Affected Equipment: Omega Container-System XXS, XS, S, SS, M, L und XL

Entry in the reserve data card: „ Bartec in accordance with Service Bulletin SB-O-200501 “.

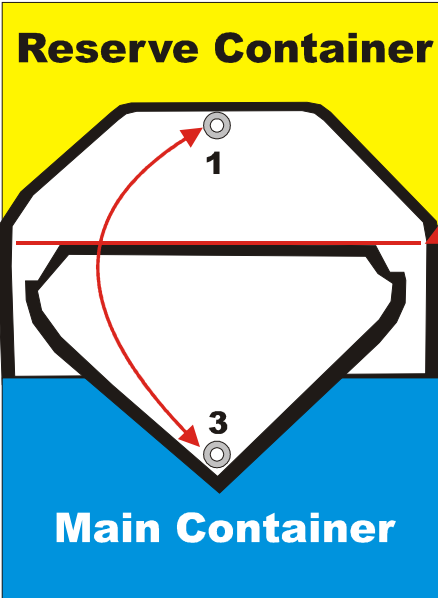
To avoid failure like written above and during improper use of the equipment in the future, the mirror (Flap No. 3 of the reserve container) must be sewed at the round corners with two short bartec to the flap No. 1 of the reserve container. This avoid contraction of the flap under tension while a line is tucked under. And it is easier to turn up the flap to release a line.

(This modification can be done by the manufacture or a approved person)

Bartec specification see drawing below!

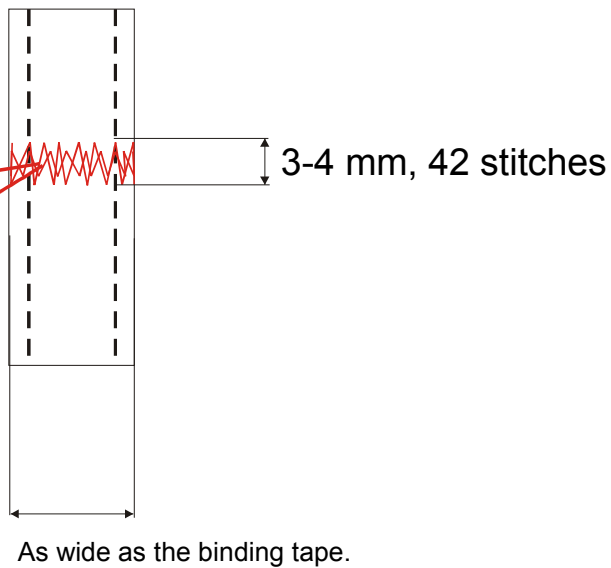
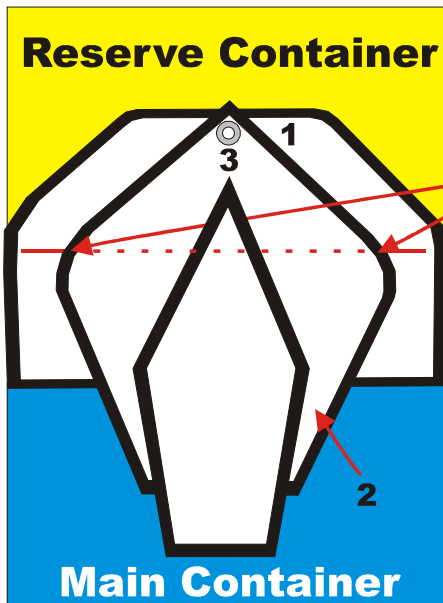
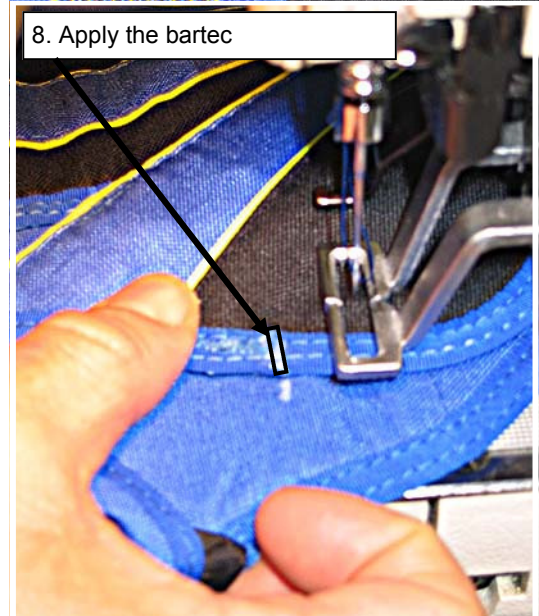
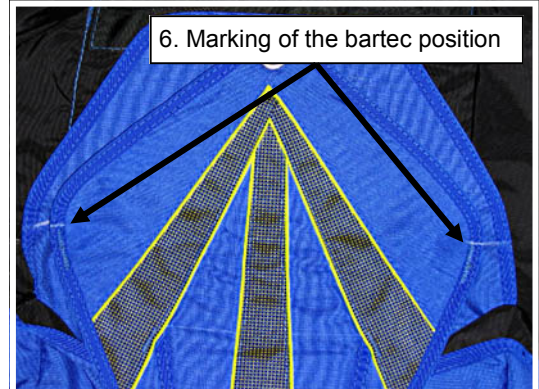
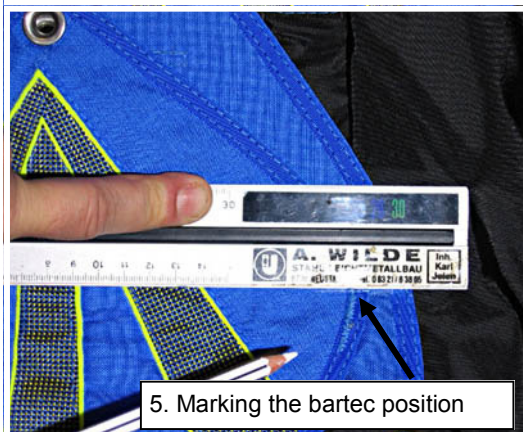
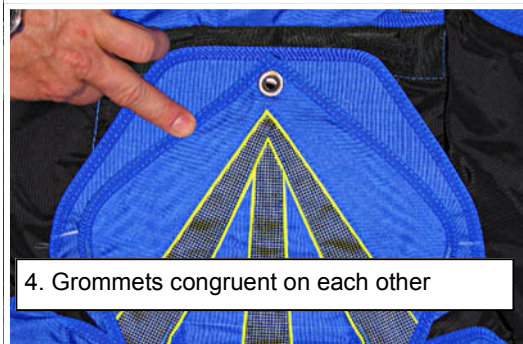
1. Mark out horizontal above the attachment of flap No. 3.
2. Put the grommets congruent on each other.
3. Apply a bartec (left and right) on the binding tape of flap No. 3 in the same height as the horizontal marking.

Use only Typ E / 40, Nylon Bonded thread!
